REFERENCE	BT_2013_FR20_14UK
DATE	June 14th, 2013
SUBJECT	Pedalbox V2 additional modifications
PART	Pedalbox

Pedalbox V2 additional modifications

- Clutch pedal

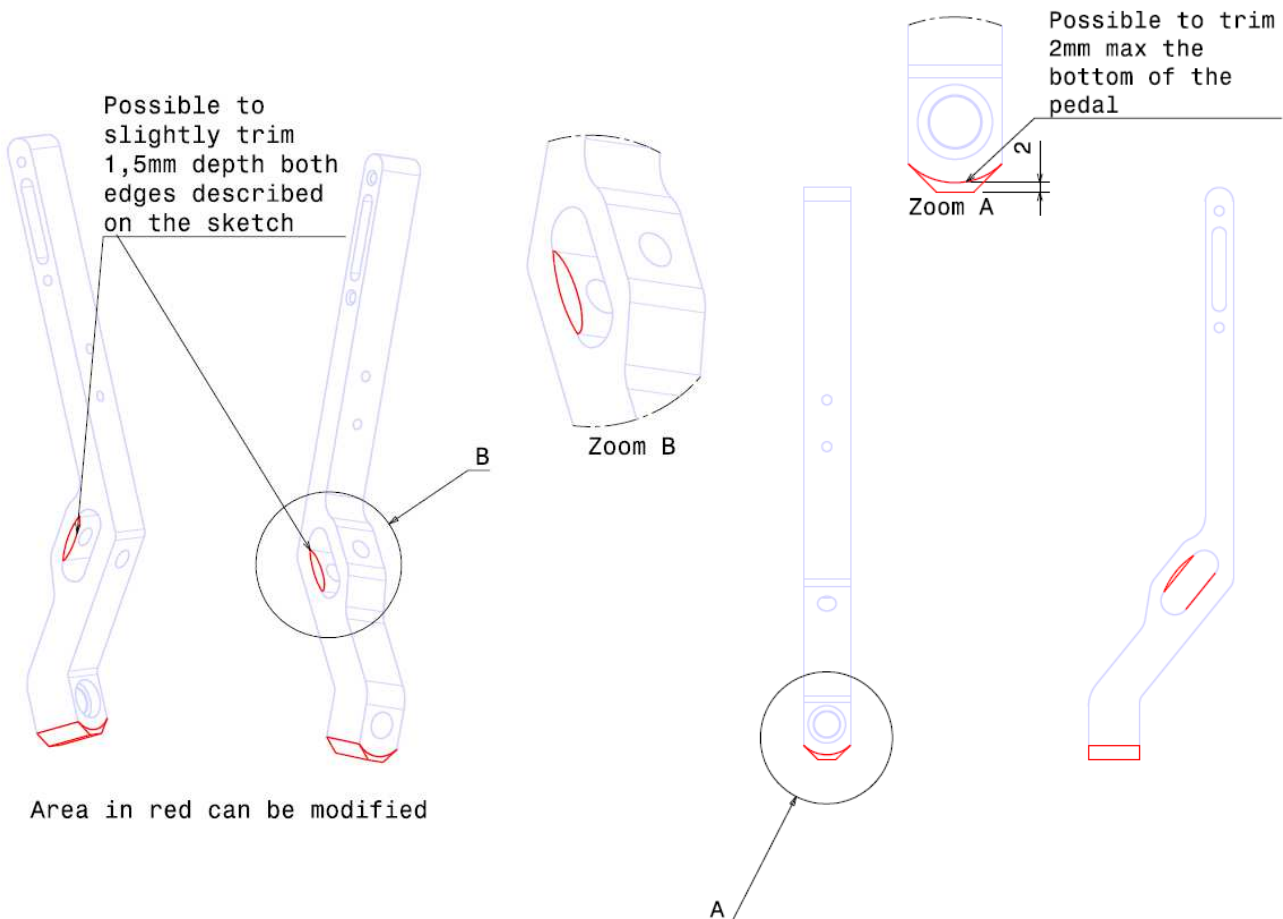
After use of some pedalboxes modified on cars, it appears that small modification may be required to ensure a good working state of the clutch pedal in every condition.

These modifications can only be applied in case of pedalbox V2 use following sketches and procedures listed below:

Due to the modification of the pivoting hole, the clutch pedal can be slightly trimmed to avoid interferences with other pedal box parts:
